Well Name: CHINCOTEAGUE 8-32 FED STATE COM	Well Location: T25S / R32E / SEC 8 / SENE / 32.1457874 / -103.6903068	County or Parish/State: LEA / NM
Well Number: 714H	Type of Well: OIL WELL	Allottee or Tribe Name:
Lease Number: NMNM061873B	Unit or CA Name:	Unit or CA Number:
US Well Number: 30-025-52975	Operator: DEVON ENERGY PRODUCTION COMPANY LP

Sundry ID: 2800580

Type of Action: APD Change

Procedure Description: Devon Energy Production Co., L.P. (Devon) respectfully requests to change the SHL, BHL, and spacing on the subject well. Devon is also updating surface casing/hole size and connections and requesting variances for break testing and offline cementing. Devon Energy Production Company, L.P. will circulate class C cement to surface behind the 10-3/4" casing. Please see attached updated C102, Drill plan, directional plan, spec sheets, break test and offline cementing variance. API: 30-025-52975 Permitted SHL: SENE, 2313 FNL, 525 FEL, 8-25S-32E Proposed SHL: SENE, 2463 FNL, 645 FEL, 8-25S-32E Permitted BHL: NENE, 20 FNL, 990 FEL, 32-24S-32E Proposed BHL: NENE, 20 FNL, 830 FEL, 32-24S-32E

WELL LOCATION AND ACREAGE DEDICATION PLAT

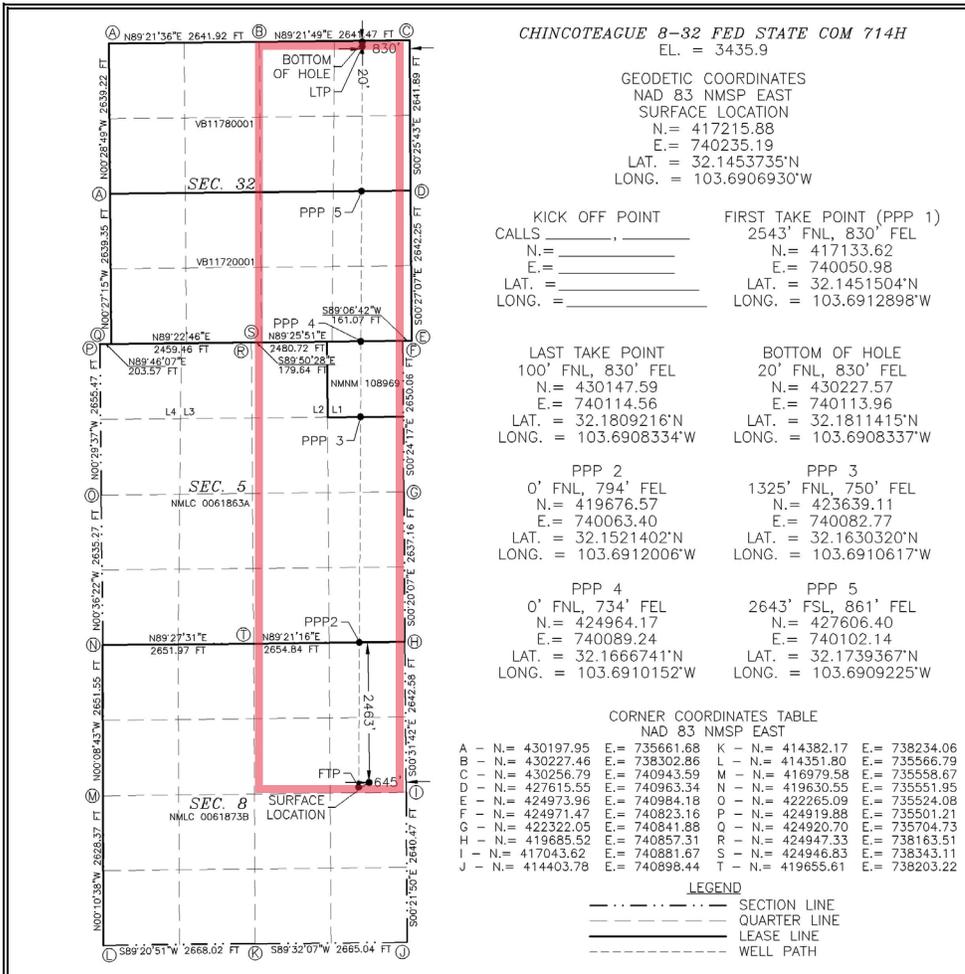
Permitted SHL: SENE, 2313 FNL, 525 FEL, 8-25S-32E

Proposed SHL: SENE, 2463 FNL, 645 FEL, 8-25S-32E

Permitted BHL: NENE, 20 FNL, 990 FEL, 32-24S-32E

Proposed BHL: NENE, 20 FNL, 830 FEL, 32-24S-32E
